Access Compliance Report

Public Rights-of-Way

| Intersection ID: 52906 | Main Street: JOHNSTON_RD | Cross Street: CLEMS_CROSSING_DR | Location: SE |
| ADA ID: 5D9C231C845E | Ramp Type: BlendTrans1 | Initial Pass/Fail: Fail | Overall Compliance: No |

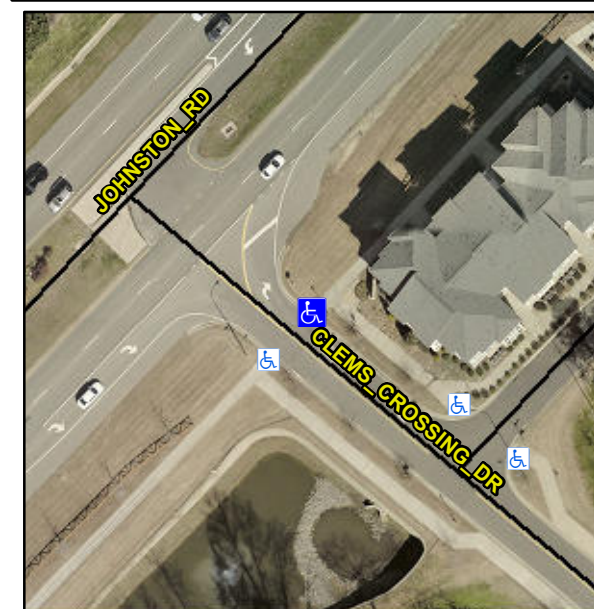
Not Found, R304.5.3

| Compliance | Description | Data | Compliance | Description | Data |
|------------|-----------------------|-------|------------|-----------------------------|------|
| Yes | Ramp Width (in) | 76.0 | No | BlendTrans XSlope (%) | 2.4 |
| | | | No | Curb Slope (%) | 13.5 |

Remove & Replace Curb Ramp With Two New Directional Ramps or Equivalent.
